City of Portland, Maine - Building or Use Permit Application
 389 Congress Street, 04101 Tel: (207) 874-8703, Fax: (207) 874-8716

Location of Construction: 548 Island Ave <i>PI</i>	Owner Name: Stevenson Monica L	Owner Address: 1501 Beacon St #1701	Phone: 207-766-2010
Business Name: n/a	Contractor Name: Weinschenk, Ric Builders	Contractor Address: 33 Island Avenue Portland	Phone: 2078283900
Lessee/Buyer's Name n/a	Phone: n/a	Permit Type: Single Family	Zone: <i>I-B</i>

To: Ric Weinschenk
CC:
From: Mike Nugent/Manager of Inspection Services
Date: 08/27/2002
Re: 548 Island Ave.

I have done a partial review of the building plans and need the following:

Reference: Curved Beam Analysis - Stevenson Residence

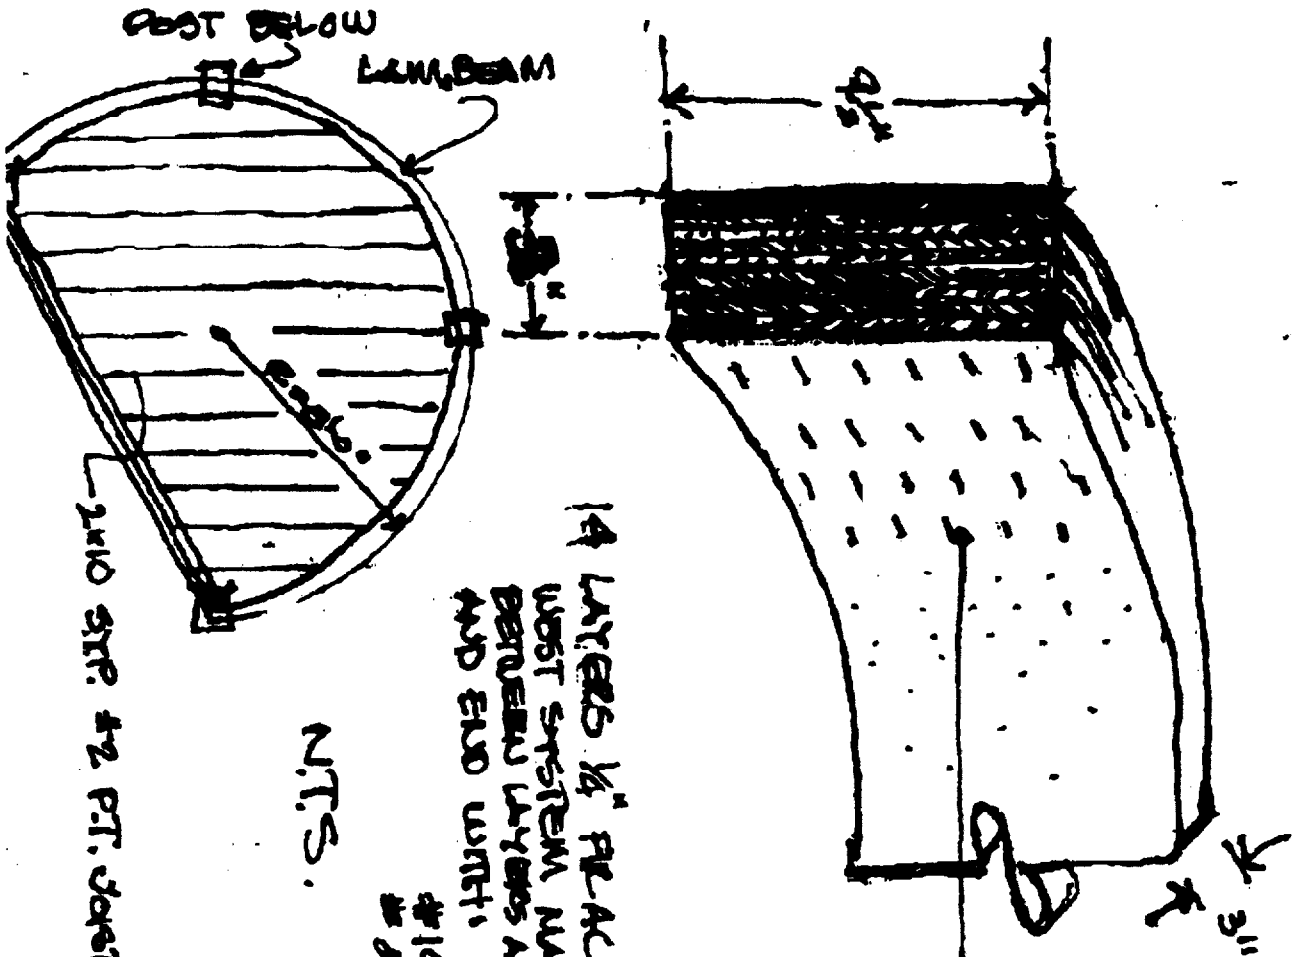
Per your request, we have analyzed the curved wood beam to be used in the construction of the deck at the Stevenson residence. The beam will consist of 14 layers of 1/4" plywood fastened together with marine epoxy and galvanized wire staples, as indicated on the enclosed sketch.

We have found that the proposed beam will be adequate to support the necessary design loads as specified in the BOCA National Building Code, 1999 edition. If you have any questions or require any further assistance, please do not hesitate to call.

ROOF PLAN

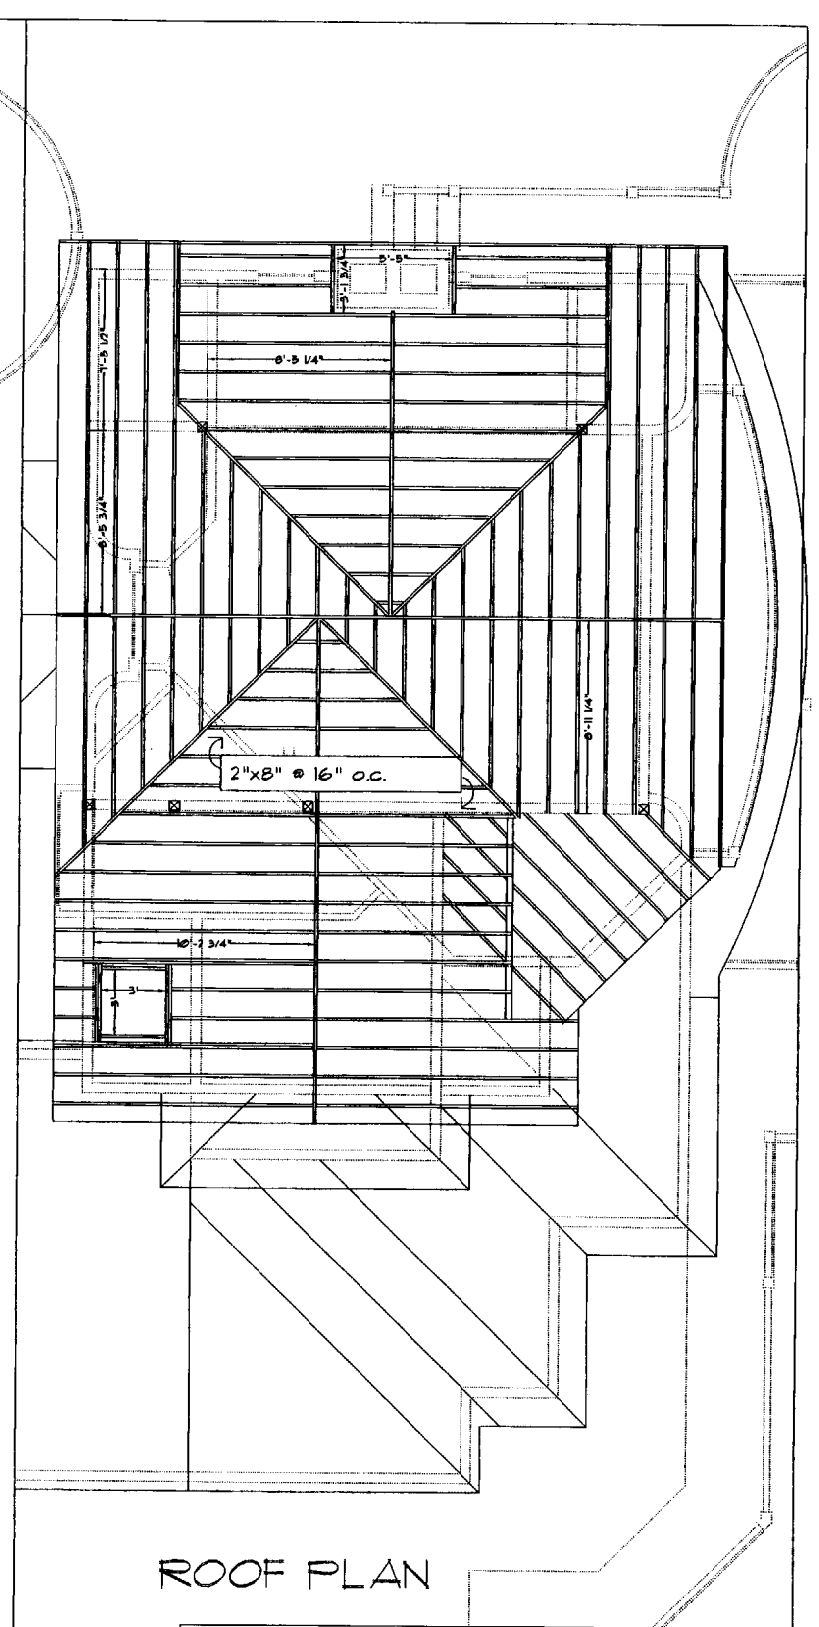
- 8) The roof detail above the lower level is omitted on the roof framing detail ✓
- 9) ½ sheathing---Want kind? *OSB*.
- 10) Floor sheathing not shown. *ADVANTEC*.

- 16) roof covering not shown *ASPHALT & #15 FELT*.
- 17) attic access not shown ✓
- 18) Need complete rubble stone fire place detail that includes **all** elements construction with dimensions.

FOUNDATION PLAN

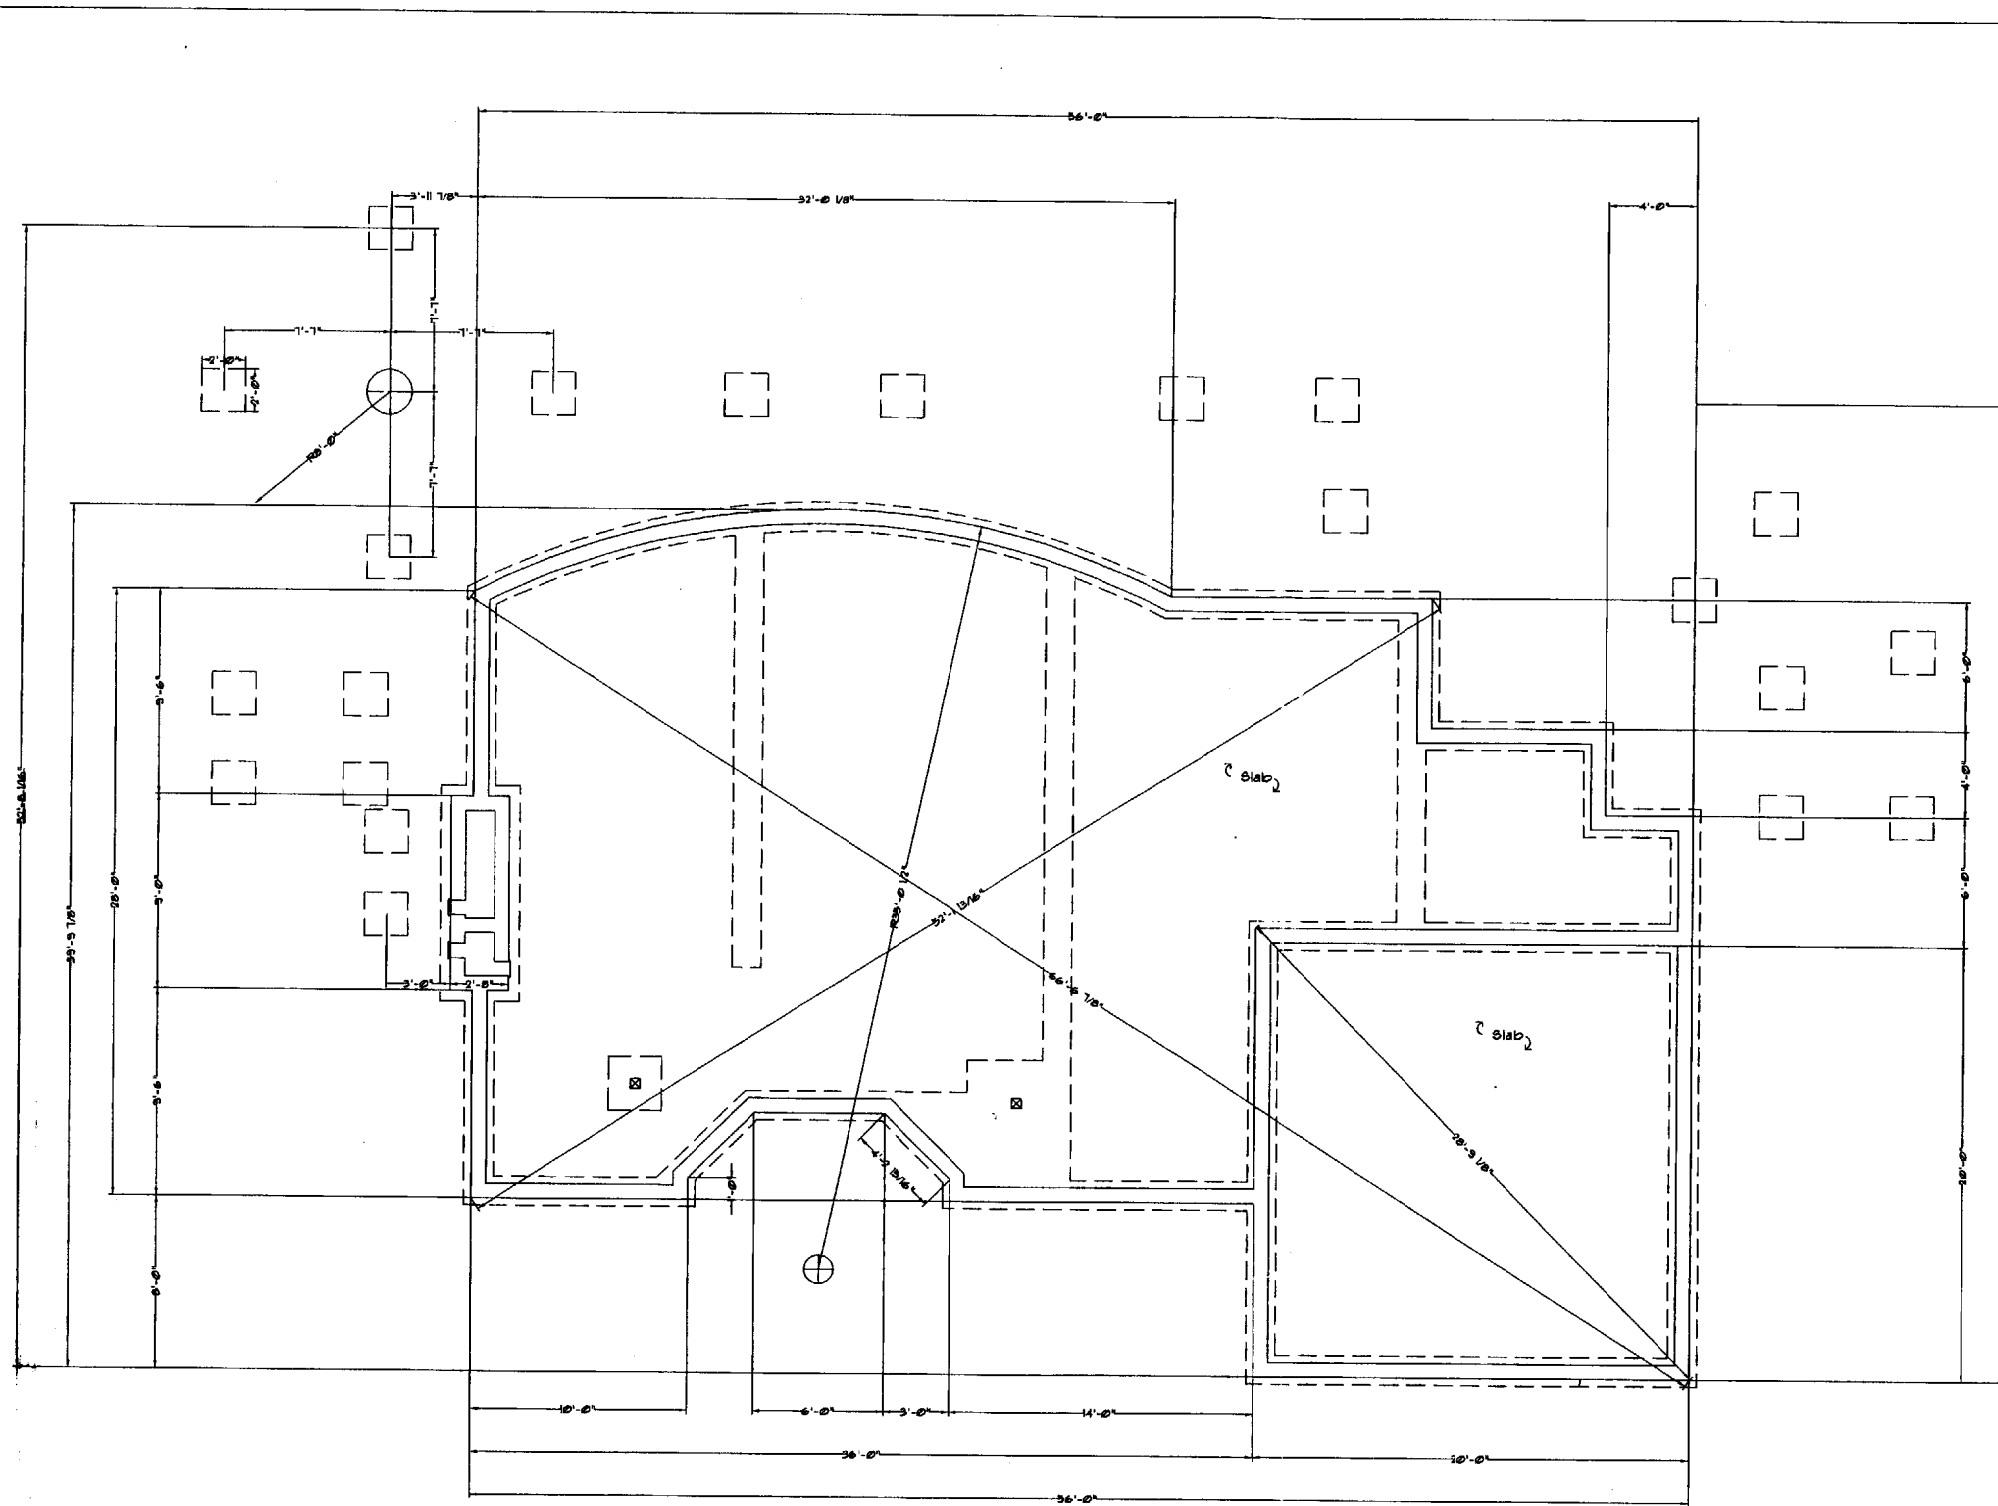
- 2) The 12" x 12" footing detail is confusing, please explain ✓
- 3) Foundation Dampproofing not shown ✓
- 4) Anchor bolts, not shown on main house foundation detail, spacing and type ✓

SITE PLAN

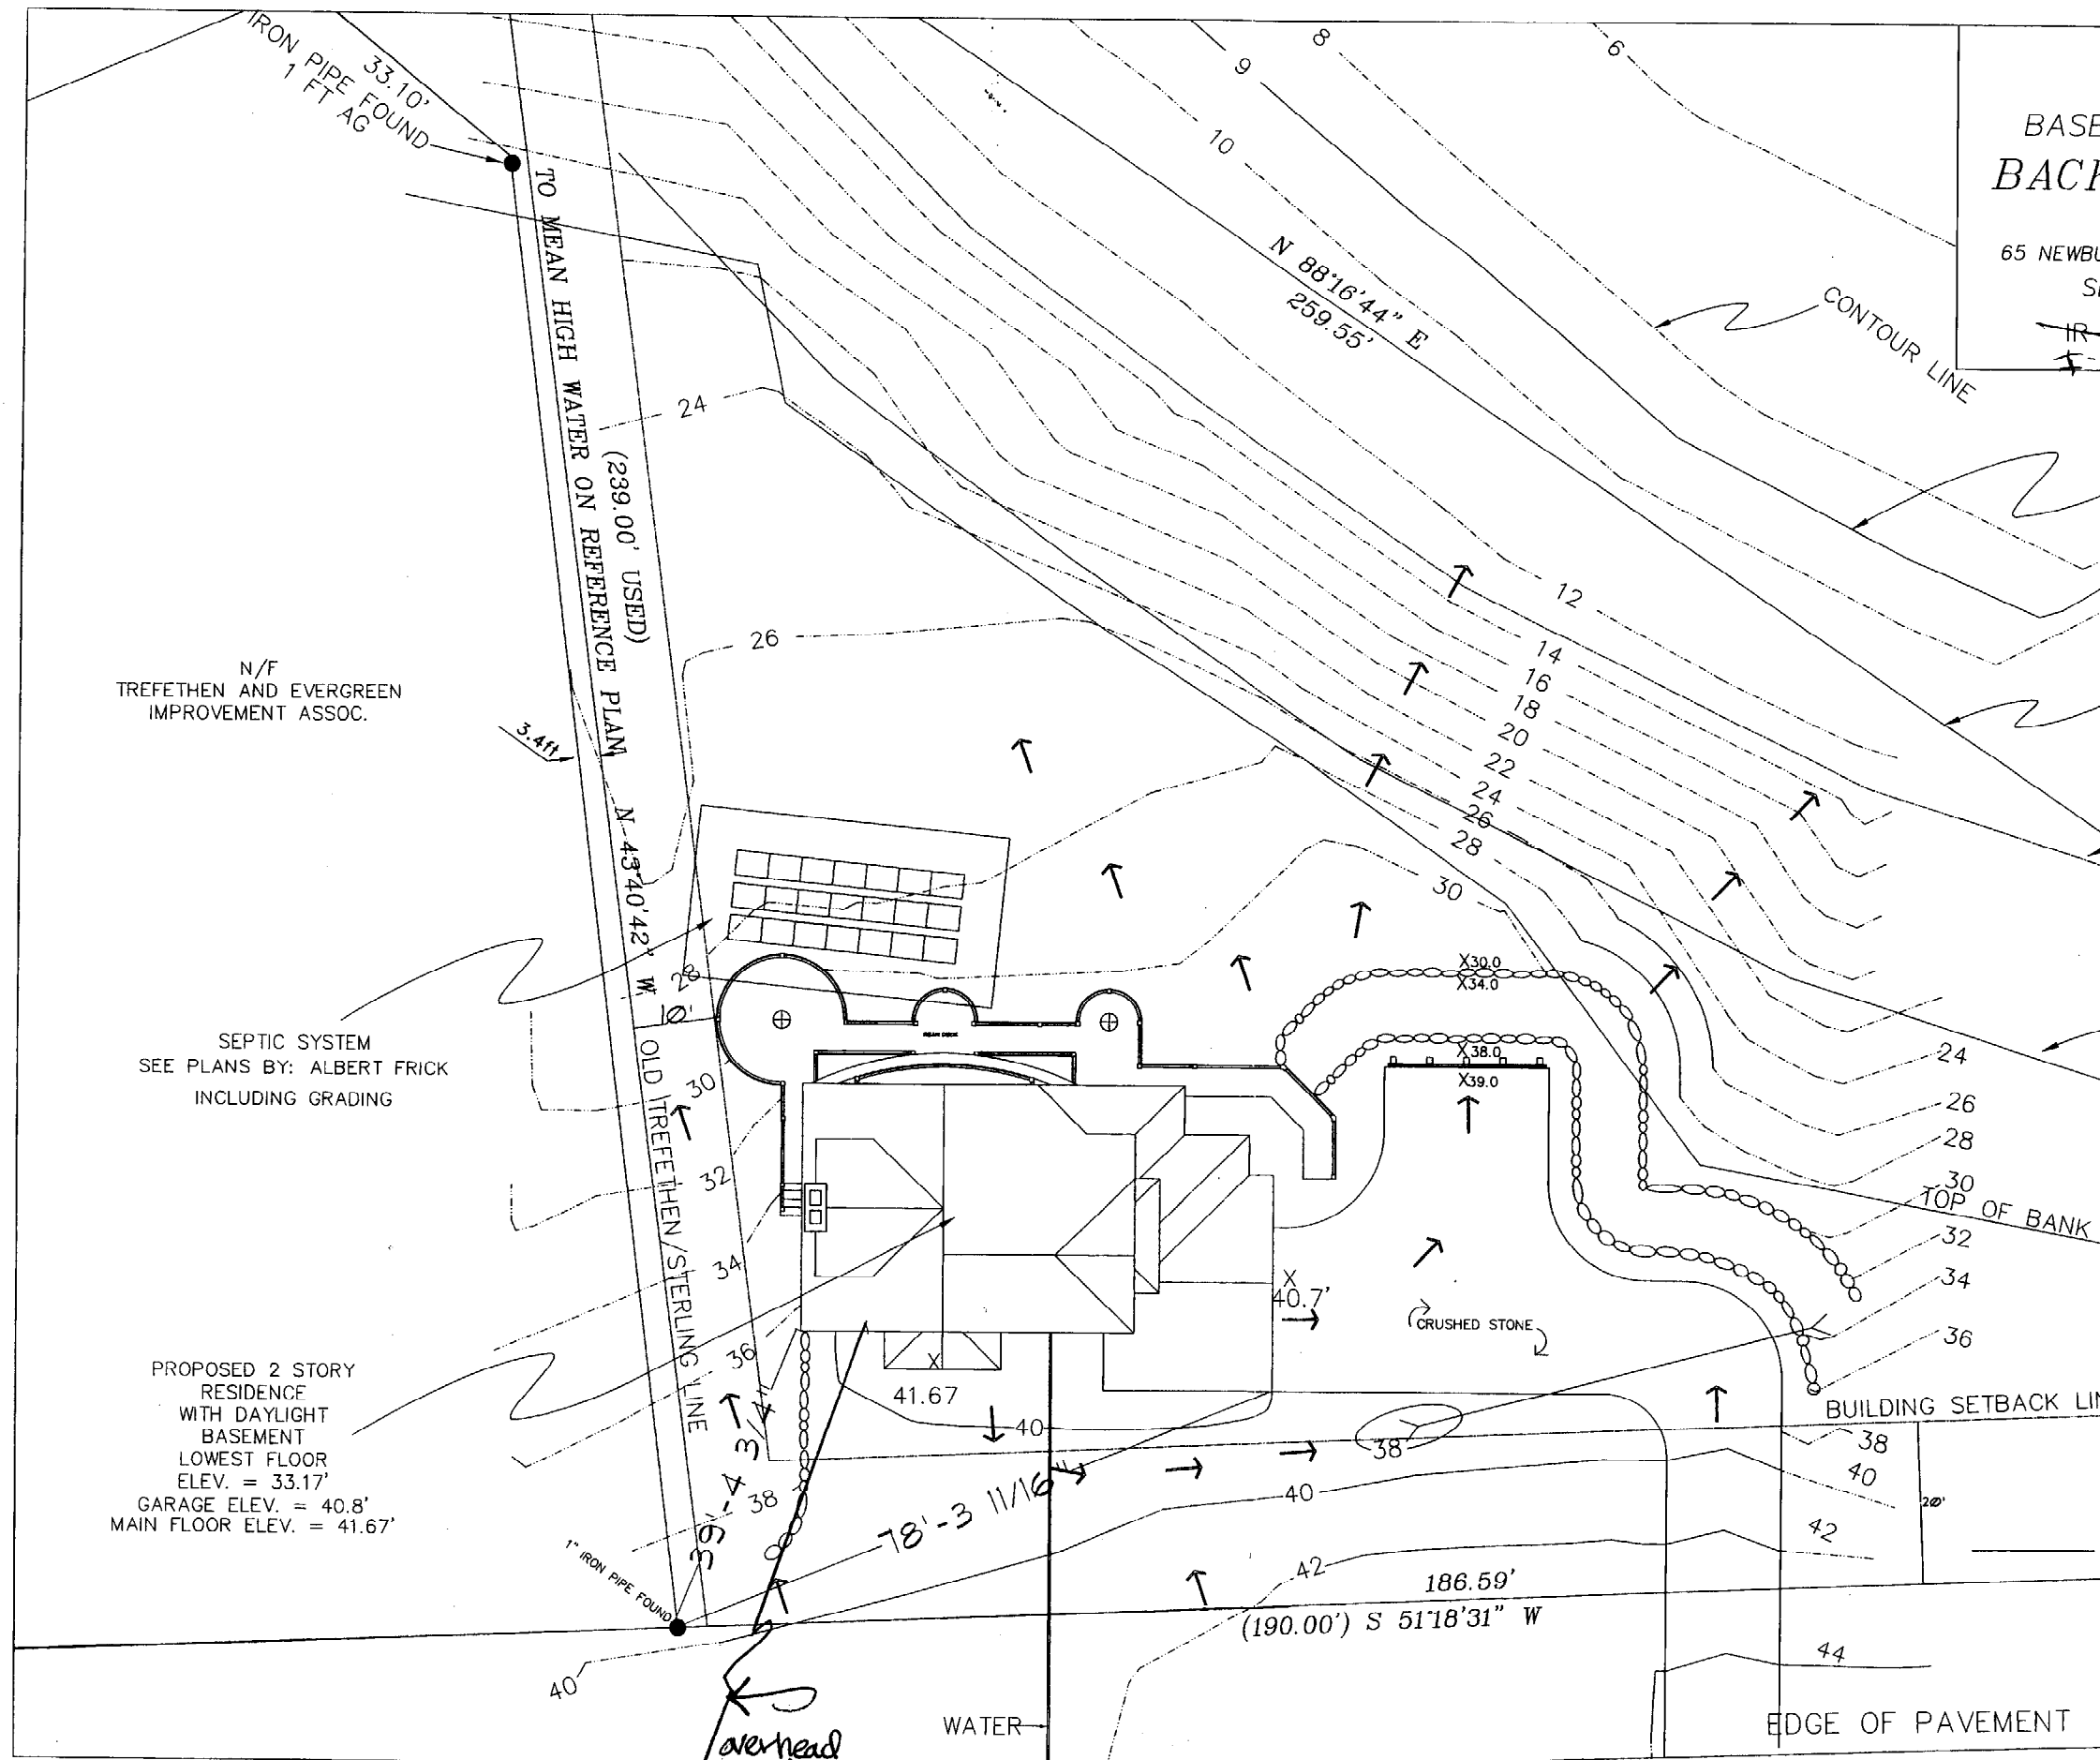
- 1) The HHE 200 form provided by Albert Frick is unacceptable, as the variances sought have been denied. Also it appears on the site plan that the structure is too close to the leach field.
- 2) The plans lack adequate structural details to establish Code compliance. Attached is a copy of the checklist used for review.
- 3) Prior to the issuance of the demo permit , an inspection must occur with a CEO, Jay Reynolds and representative from your surveying company to establish existing grade for the purpose of documenting Building Height, which will be verified by you surveyor when the roof framing is in place.
